November 10, 2017

To: All bidders of Town of Delhi Municipal Swimming Pool Project

Re: Addendum No. 4 to Construction Contract Documents

DRAWING NO:
 SECTION NO:
 SHEET NO.
 S-1/2

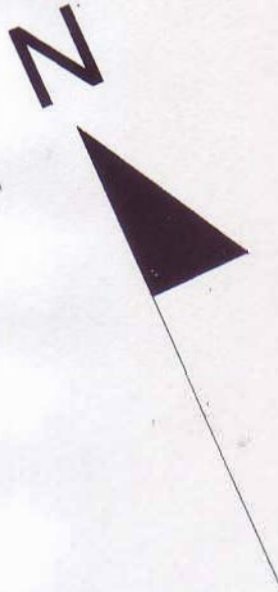
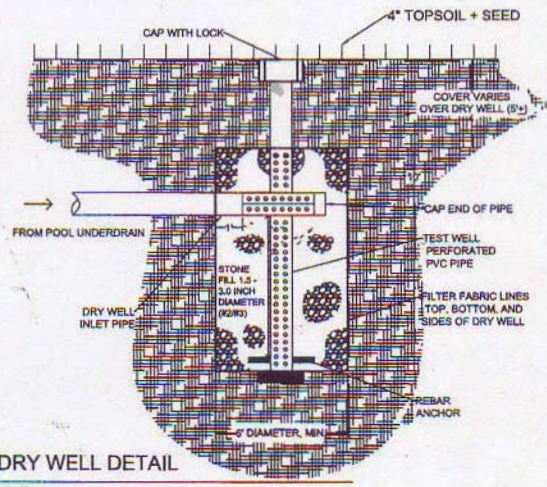
7 – The documents indicate for the contractor to excavate the site APPROXIMATELY 8 feet. What does APPROXIMATELY mean? There should be specific elevations given. **The general contractor will be required to excavate (the Town of Delhi is no longer providing any excavation services) only as necessary for the construction of the pool, bathhouse, and other construction items except for plumbing and electrical work excavation by those trades; no site wide construction is required or expected; delete said notes to that effect as shown on the reduced marked partial S-1/2 drawing.**

8 – How big of an area is the contractor to excavate 8 feet? There should be specific dimensions given. **See 7. Above. There is no longer any need to over-excavate the site.**

9 – The documents indicate the town will fill the site to the final elevations. When will this be done? Before the pool is constructed? In which case the contractor will have to excavate down for the pool. Or after the pool is constructed? **The Town is no longer going to provide construction assistance on the work. The GC will be responsible. The GC will be required to put in place and compact Town furnished select earth to 100% standard proctor density as required below the bathhouse, the kid's pool and other construction items to bring them up to necessary grade prior to actual construction as the Town is no longer providing this service. Filling operations will be by the GC to bring the site to final grades shown on Drawing S-1/2 as issued in Addendum No. 1.**

13 – One note on drawing S-1/2 indicates the fence is 6 foot high. One note indicates the fence is 8 feet high. One note indicates the fence is 3 foot high. **See 12. above**

NOTE: ~~THE EXISTING SITE WILL BE EXCAVATED OF DEMOITION & DEBRIS MATERIAL TO AN APPROX. 0'0" DEPTH. CLEAN SELECT FILL MATERIALS WILL THEN BE PROVIDED BY OTHERS, FULLY COMPACTED, TO THE APPROXIMATE POOL BOTTOM ELEVATIONS SHOWN MINUS ONE FT. (1'), HEREON. ALL EROSION MANAGEMENT, GRADING, TOP SOIL, SEEDING, & OTHER WORK FOR FINAL COMPLETION SHALL BE BY CONTRACT G-1~~

NOTE: ~~TOWN WILL FILL SITE TO APPROXIMATE GRADES REQUIRED FOR CONSTRUCTION. CONTRACTOR DOES FINAL GRADING, TOPSOIL, SEED, ETC.~~
